# GTB Proposals to amend Regulations Nos. 7 and 48 to introduce Interdependent Lamp Systems

(ECE/TRANS/WP.29/GRE/2009/62 and ECE/TRANS/WP.29/GRE/2009/63Rev1)

## Additional Explanation

***Revised 03 December 2009***

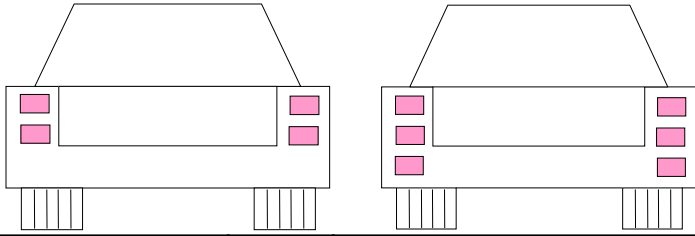
- All Interdependent lamps operate together and are type approved as a “single lamp” (New Paragraph 2.7.30)
- No issues associated with lamps on movable components
- All existing requirements in R48 and R07 apply

Position	R48	Existing requirements unchanged
Photometry	R07	Existing requirements unchanged
Geometric Visibility	R48	Para 2.13 Revised to only contain definitions. Requirements moved to a new paragraph 5.28 Para.5.28 (In the case of an interdependent lamp system, the above requirements shall be fulfilled when all its Interdependent lamps are operated together.) Para5.18 (Revised ) Para5.21 (existing)
Failure Provisions	R07	Para 6.1 (a) all light sources which are connected in series are considered to be one light source; (b) the lamp shall comply with the minimum intensity required when any one light source has failed. However, for lamps designed for only two light sources, 50 per cent of the minimum intensity in the axis of reference of the lamp shall be considered sufficient, provided that a note in the communication form states that the lamp is only for use on a vehicle fitted with an operating tell-tale which indicates when any one of these two light sources has failed;

Single Lamp Definitions and Requirements	R48	Para 2.16.1.d added to ensure that the distance between adjacent apparent surfaces does not exceed 75 mm when measured perpendicularly to the reference axis. This replaces the existing provisions with a more stringent requirement that is achievable with an interdependent lamp system to provide an improved lit appearance. Para. 5.7.2.2 amended Para 5.18 amended
Electrical Connections	R48 R07	Para 2.7.30.1 (New definition) Para 5.11.2 amended Para 6.5.7 amended Para 5.9 added

## ALL Interdependent Lamps (“Y” Lamps) Mounted on Moving Component(s)

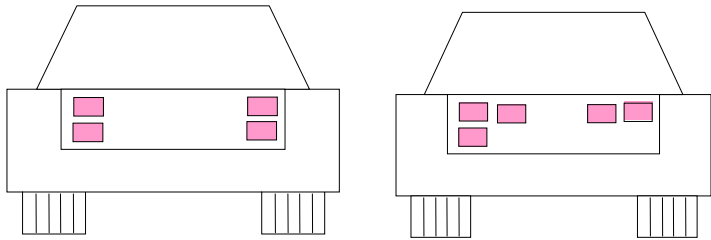
- All Interdependent lamps operate together and are type approved as a “single lamp” (New Paragraph 2.7.30)
- All existing requirements in R48 and R07 apply including special provisions for lamps mounted on movable components

Position	R48	Existing requirements unchanged
Photometry	R07	Existing requirements unchanged
Geometric Visibility	R48	<p>Para 2.13 Revised to only contain definitions. Requirements moved to a new paragraph 5.28</p> <p>Para.5.28 (In the case of an interdependent lamp system, the above requirements shall be fulfilled when all its Interdependent lamps are operated together.)</p> <p>Para5.18 (Revised ) and 5.18.4 (a) added to assure adequate geometric visibility is maintained when the moving component is in its fixed open position.</p> <p>Para5.21 (existing)</p>
Failure Provisions	R07	<p>Para 6.1</p> <p>(a) all light sources which are connected in series are considered to be one light source;</p> <p>(b) the lamp shall comply with the minimum intensity required when any one light source has failed. However, for lamps designed for only two light sources, 50 per cent of the minimum intensity in the axis of reference of the lamp shall be considered sufficient, provided that a note in the communication form states that the lamp is only for use on a vehicle fitted with an operating tell-tale which indicates when any one of these two light sources has failed;</p>

Single Lamp Definitions and Requirements	R48	<p>Para 2.16.1.d added to ensure that the distance between adjacent apparent surfaces does not exceed 75 mm when measured perpendicularly to the reference axis. This replaces the existing provisions with a more stringent requirement that is achievable with an interdependent lamp system to provide an improved lit appearance.</p> <p>Para. 5.7.2.2 amended</p> <p>Para 5.18 amended</p>
Electrical Connections	R48 R07	<p>Para 2.7.30.1 (New definition)</p> <p>Para 5.11.2 amended</p> <p>Para 6.5.7 amended</p> <p>Para 5.9 added</p>

# Interdependent Lamps (“Y” Lamps) Mounted on Fixed and Moving Component(s)

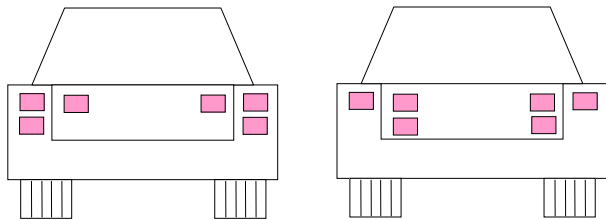
- All Interdependent lamps operate together and are type approved as a “single lamp” (New Paragraph 2.7.30)
- All existing requirements in R48 and R07 apply including special provisions for lamps mounted on movable components
- The Applicant shall specify the interdependent lamp or the combination of interdependent lamps that fulfil the photometric requirements. The Geometric Visibility requirements are fulfilled when all interdependent lamps are operated together and the moving parts are in their fixed closed position. When the moving parts are in their fixed open position the geometric visibility is assured within the angles defined by the photometric test points according to the provisions of new Para.5.18.4.

Position	R48	Existing requirements unchanged
Photometry	R07	Existing requirements unchanged
Geometric Visibility	R48	<p>Para 2.13 Revised to only contain definitions. Requirements moved to a new paragraph 5.28</p> <p>Para.5.28 (In the case of an interdependent lamp system, the above requirements shall be fulfilled when all its Interdependent lamps are operated together.)</p> <p>Para5.18 (Revised ) and 5.18.4 (b) added to assure adequate geometric visibility is maintained when the moving component is in its fixed open position.<b>(5.18.4(b): “The inboard geometric visibility requirement is deemed to be satisfied if this(these) interdependent lamp(s) still conform(s) to the photometric values prescribed in the field of light distribution for the approval of the device, at all fixed positions of the movable component(s).”</b>)</p> <p>Para5.21 (existing)</p>
Failure Provisions	R07	<p>Para 6.1</p> <p>(a) all light sources which are connected in series are considered to be one light source;</p> <p>(b) the lamp shall comply with the minimum intensity required when any one light source has failed. However, for lamps designed for only two light sources, 50 per cent of the minimum intensity in the axis of reference of the lamp shall be considered sufficient, provided that a note in the communication form states that the lamp is only for use on a vehicle fitted with an operating tell-tale which indicates when any one of these two light sources has failed;</p>

Single Lamp Definitions and Requirements	R48	<p>Para 2.16.1.d added to ensure that the distance between adjacent apparent surfaces does not exceed 75 mm when measured perpendicularly to the reference axis. This replaces the existing provisions with a more stringent requirement that is achievable with an interdependent lamp system to provide an improved lit appearance.</p> <p>Para. 5.7.2.2 amended</p> <p>Para 5.18 amended</p>
Electrical Connections	R48  R07	<p>Para 2.7.30.1 (New definition)</p> <p>Para 5.11.4 amended</p> <p>Para 6.5.7 amended</p> <p>Para 5.9 added</p>

# Wide Tail-gate or Trunk Opening – Geometric Visibility Implications

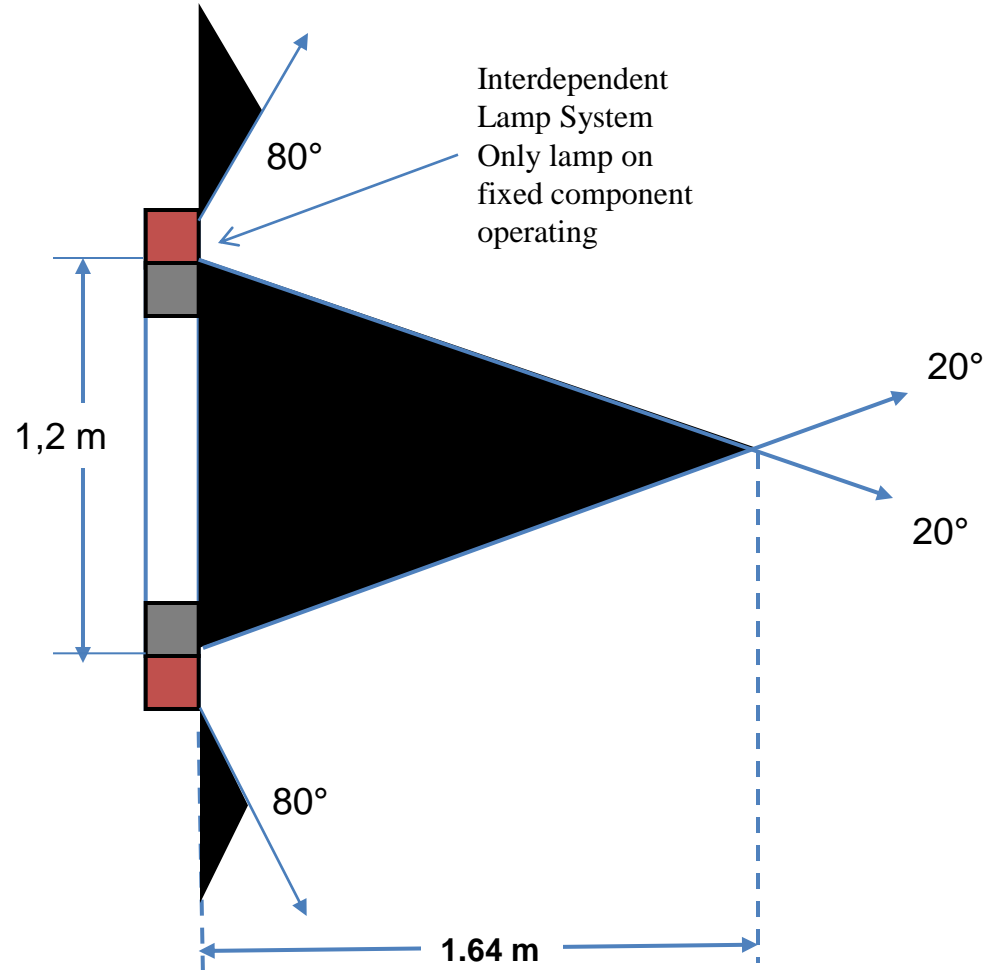
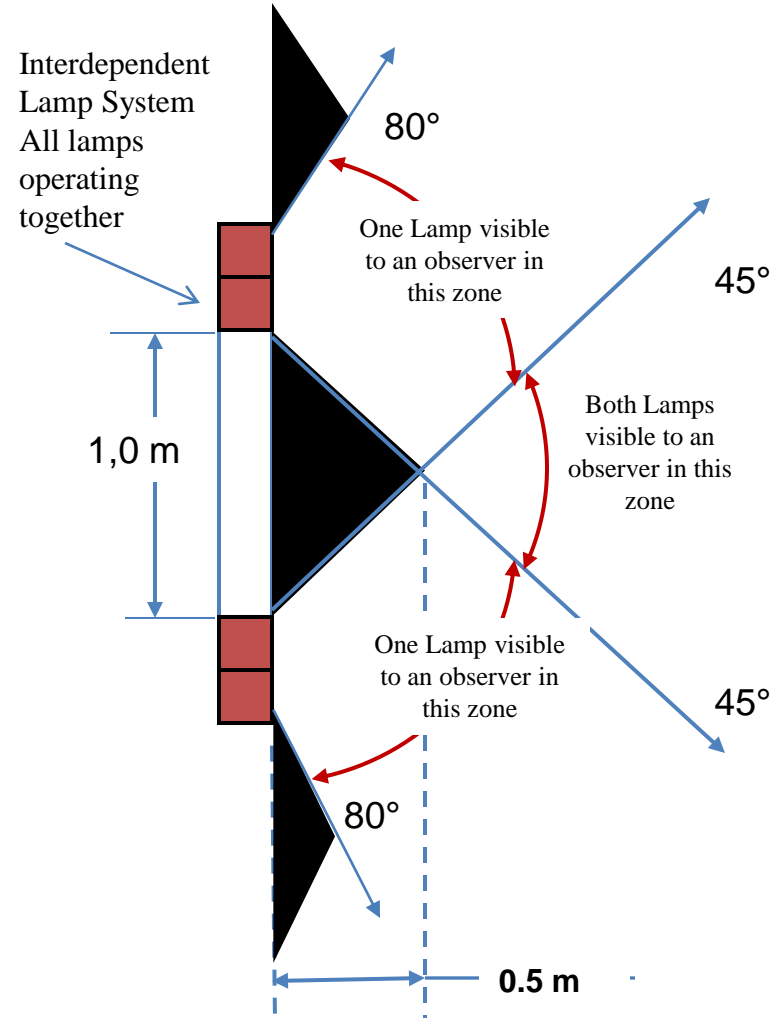
**Tail gate or Trunk in normal closed position**

All interdependent lamps satisfy the photometric requirements. Geometric visibility assured to 45° inboard

**Tail gate or Trunk in fixed open position**

The interdependent lamp mounted on the fixed component satisfies photometric requirements. Geometric visibility assured within the photometric grid (20° inboard)

# Distance Between Adjacent Apparent Surfaces

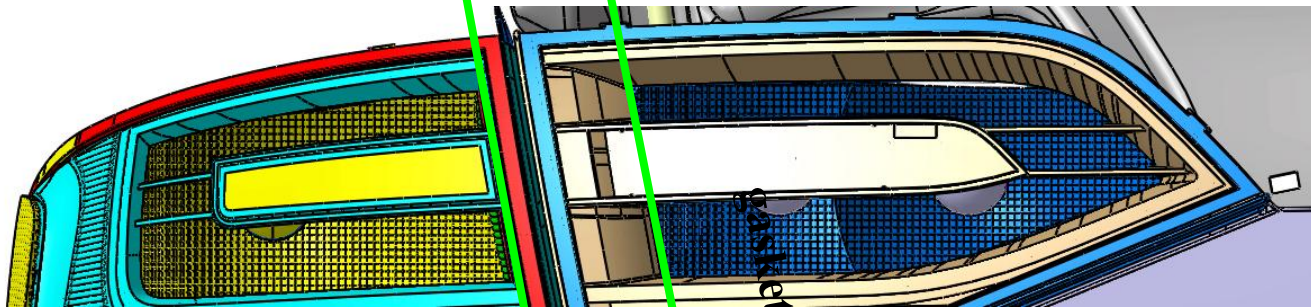
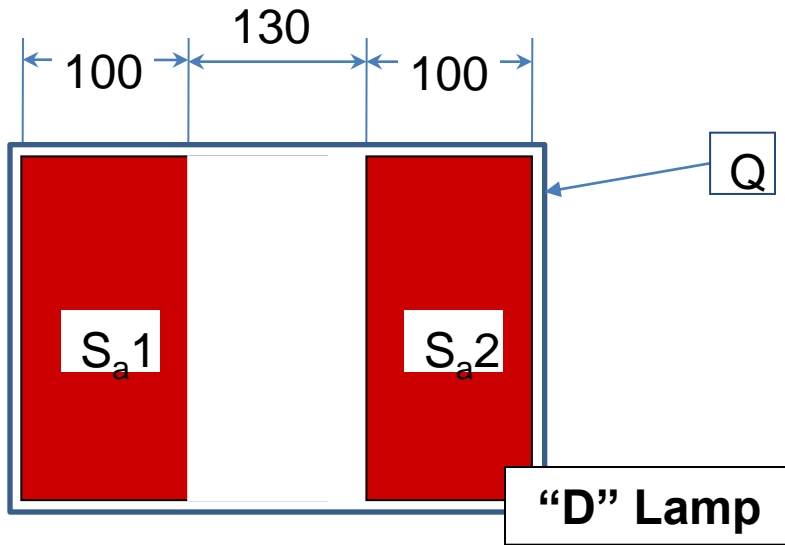
Although the two lamps are installed with a minimum  
gap the apparent surfaces are separated due to the  
physical limitations of the lamp construction

Vehicle bodywork and sealing  
gaskets prevent light emitting  
surfaces in this zone

75mm Maximum Proposed

## Effect of the Proposed Para. 2.16.1(d)

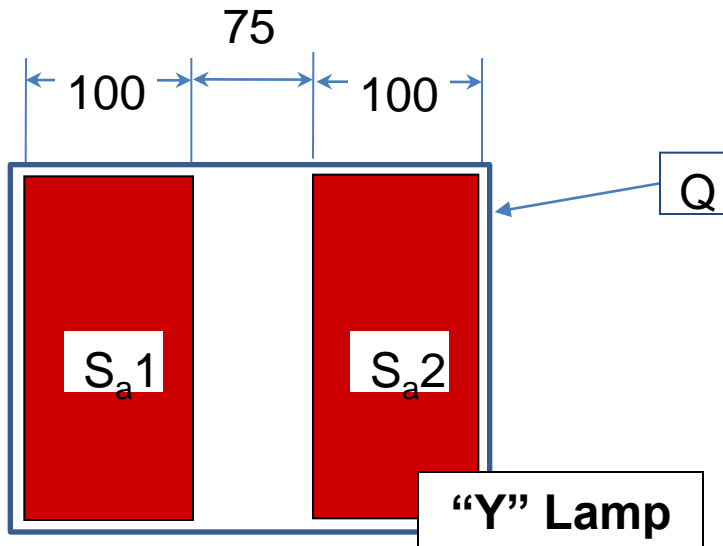
A Comparison of the effects of the "60%" Rule and the 75mm Separation

Para. 2.16.1(b)

"the projection of their apparent surfaces in the direction of the reference axis occupies not less than 60 per cent of the smallest quadrilateral circumscribing the projections of the said apparent surfaces in the direction of the reference axis"

Para. 2.16.1(d)

"Any interdependent lamps ("Y" Lamps) in an interdependent lamp system having the same function, approved together as type "Y" and installed so that the distance between adjacent apparent surfaces does not exceed 75 mm when measured perpendicularly to the reference axis"
